**RE: 808 G Street SE (Square 0926, Lot 0806)
 26-Z-PDRM-00025**

This letter will confirm the substance of your meeting with my staff on December 12, 2025. The property at 808 G Street SE (Square 0926, Lot 0806) is zoned RF-1 and is currently improved with a semi-detached building in single household use and an accessory building serving as a garage in the rear yard. The lot is an Assessment and Taxation (A&T) lot and a subdivision to convert the A&T lot to a record lot will be required as part of a permit application for any footprint expansions or work requiring a Wall Check.

ADDITION, ALTERATION AND REPAIR PERMIT
808 G STREET SE
WASHINGTON, DC 20003

COVER SHEET

SHEET NUMBER
A-000
SHT. 1 OF 6

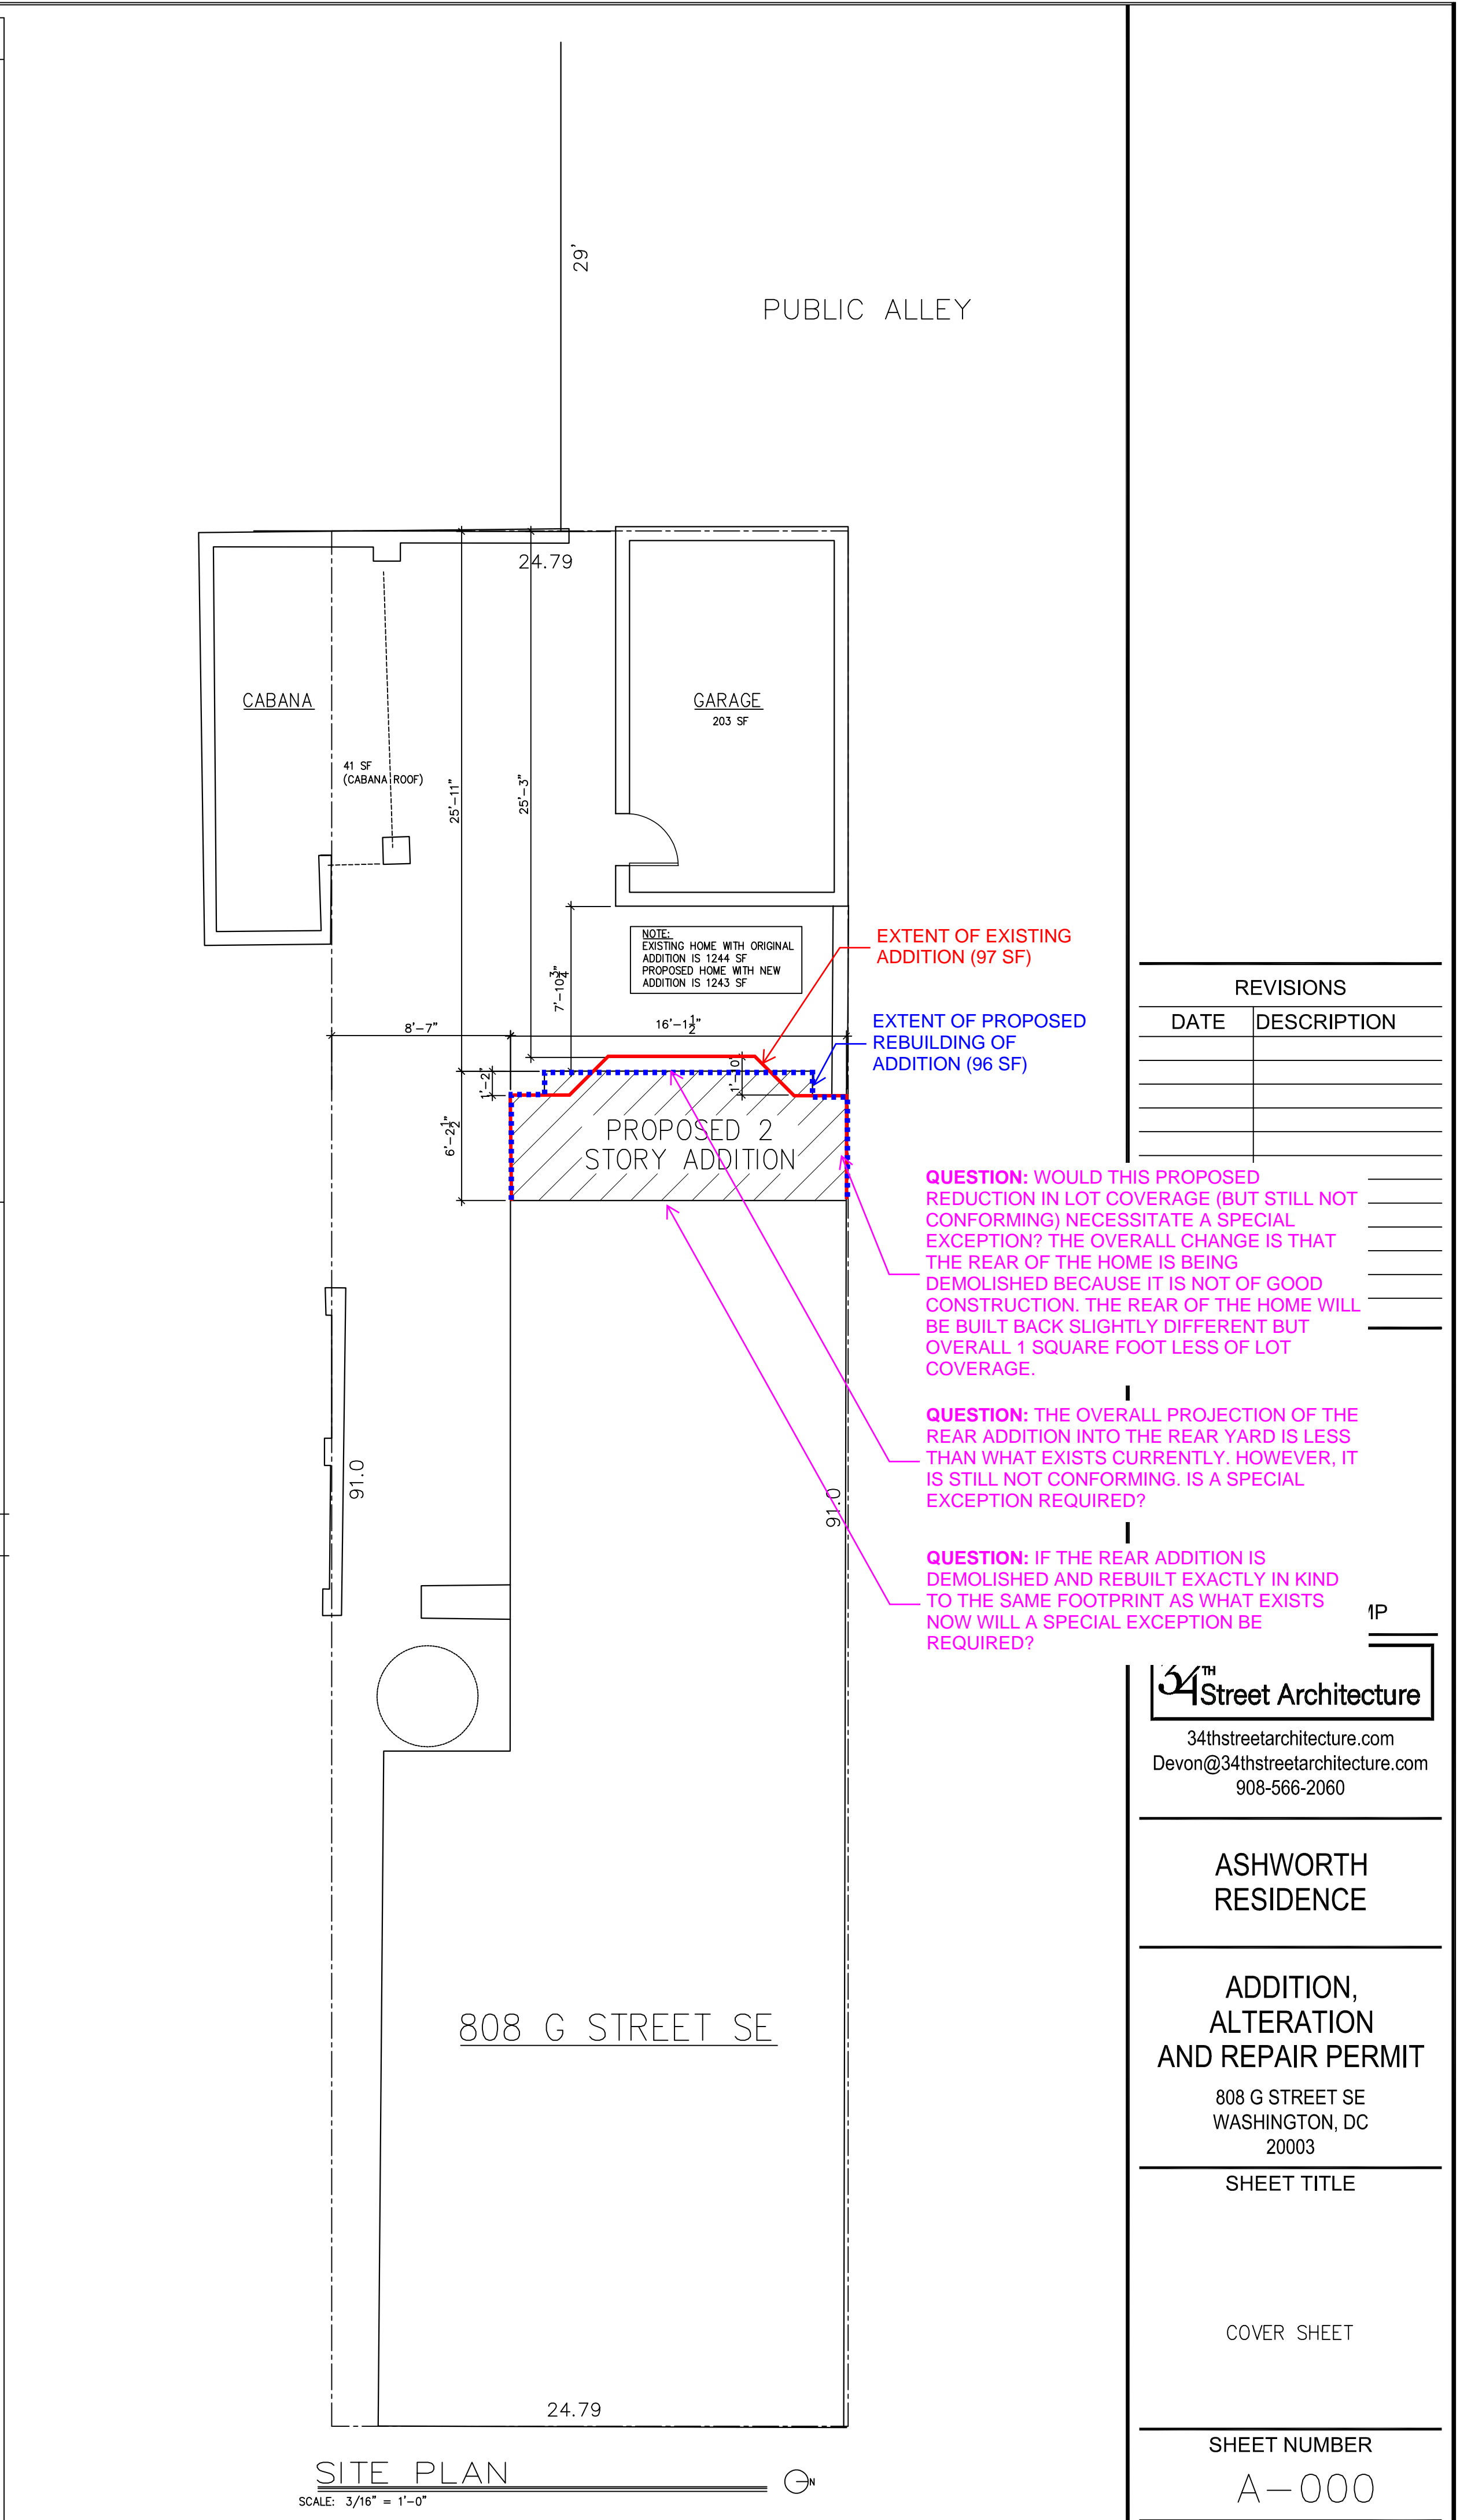
EXTENT OF EXISTING ADDITION (97 SF)

EXTENT OF PROPOSED REBUILDING OF ADDITION (96 SF)

QUESTION: WOULD THIS PROPOSED REDUCTION IN LOT COVERAGE (BUT STILL NOT CONFORMING) NECESSITATE A SPECIAL EXCEPTION? THE OVERALL CHANGE IS THAT THE REAR OF THE HOME IS BEING DEMOLISHED BECAUSE IT IS NOT OF GOOD CONSTRUCTION. THE REAR OF THE HOME WILL BE BUILT BACK SLIGHTLY DIFFERENT BUT OVERALL 1 SQUARE FOOT LESS OF LOT COVERAGE.

QUESTION: THE OVERALL PROJECTION OF THE REAR ADDITION INTO THE REAR YARD IS LESS THAN WHAT EXISTS CURRENTLY. HOWEVER, IT IS STILL NOT CONFORMING. IS A SPECIAL EXCEPTION REQUIRED?

QUESTION: IF THE REAR ADDITION IS DEMOLISHED AND REBUILT EXACTLY IN KIND TO THE SAME FOOTPRINT AS WHAT EXISTS NOW WILL A SPECIAL EXCEPTION BE REQUIRED?

The property is nonconforming for lot occupancy, and the project proposes the in-kind replacement of an existing two-story rear addition with a slightly modified footprint that results in a more conforming condition with respect to lot occupancy.

Pursuant to C-201.1 and C-202.1 ordinary repairs, alterations, and modernizations, including structural alterations, shall be permitted to existing nonconforming structures provided the nonconforming structure is not enlarged upon, expanded, or extended.

In cases of a partial demolition of a building in which the footprint is not being expanded, at least four (4) feet of height of the enclosing perimeter walls, as measured from existing grade adjacent to and outside those walls, must be retained so as not to constitute a complete removal of a building or a zoning raze. I have reviewed the drawing set attached to this Confirmation, depicting demolition of the rear atrium addition and retention of the front and side exterior enclosing walls and confirm that the project does not qualify or will not be considered a zoning raze. The proposed project as presented will be classified as an addition, alteration and repair by my department for purposes of applying the applicable Zoning Regulations. It is understood that final design may alter this number or percentage, but that the classification as a non-zoning raze or as an addition/alteration project will be valid as long as four (4) feet of the enclosing perimeter wall is maintained. Failure to comply with this requirement will result in the denial of the building permit application and relief from the Board of Zoning Adjustment will be required prior to the approval of the building permit. Similarly, if during the construction process, less than a minimum of four (4) feet of the total existing exterior enclosing perimeter wall area is retained, the project will be deemed to be a zoning raze and construction must stop until relief from the Board of Zoning Adjustment has been granted. In addition, the Department of Buildings will take enforcement action to stop the work and issue fines.

Accordingly, if all other applicable zoning requirements are met, then when you file the plans for a building permit with DOB, this office will approve the drawings that are consistent with the information noted above.
